Access Compliance Report

Public Rights-of-Way

(Curb Ramps)

Intersection ID: 43657	Main Street: TAYLOR RIDGE LN	Cross Street: SWANN BRANCH DR	Location: SE
ADA ID: C88BA052F4B3	Ramp Type: Perp	Initial Pass/Fail: Fail	Overall Compliance: No
Severity Score: 10			
Codes/Mitigation Info/Possible Solution		Field Measurements/Component Compliance

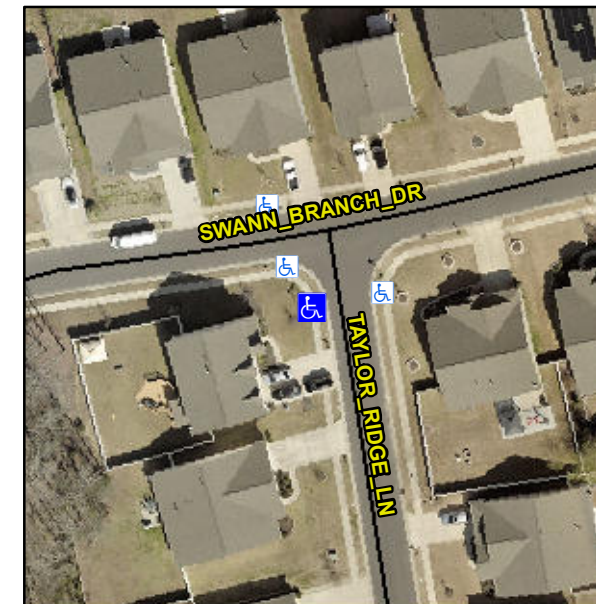
Not Found, R304.5.1, R304.5.3

Compliance	Description	Data	Compliance	Description	Data
N/A	Ramp Length (in)	48.0	Yes	Ramp Slope (%)	5.8
No	Ramp Width (in)	47.0	No	Ramp XSlope (%)	3.7
N/A	Flare Type LT	N/A	N/A	Flare Type RT	N/A
N/A	Flare Slope LT (%)	N/A	N/A	Flare Slope RT (%)	N/A
N/A	Flare Traversable LT?	N/A	N/A	Flare Traversable RT?	N/A
N/A	Landing Length (in)	N/A	N/A	DWS Provided?	N/A
N/A	Landing Width (in)	N/A	N/A	DWS Contrast?	N/A
N/A	Landing Slope (%)	N/A	N/A	DWS Length (in)	N/A
N/A	Landing X Slope (%)	N/A	N/A	DWS Full Width?	N/A
N/A	Landing Curb? (Y/N)	N/A	N/A	DWS Offset (in)	N/A
N/A	Shared Landing?	N/A			
N/A	Gutter Ponding?	N/A	N/A	Gutter Slope (%)	N/A
N/A	Gutter Lip Ht (in)	N/A	N/A	Gutter X Slope (%)	N/A
N/A	Painted X Walk1?	No	N/A	Painted X Walk2?	N/A
	X Walk 1 Direction	To W		X Walk 2 Direction	N/A
N/A	X Walk 1 Width (in)	N/A	N/A	X Walk 2 Width (in)	N/A
	X Walk 1 Slope (%)	3.8		X Walk 2 Slope (%)	N/A
	X Walk 1 X Slope (%)	2.3		X Walk 2 X Slope (%)	N/A

Remove & Replace Entire Ramp.
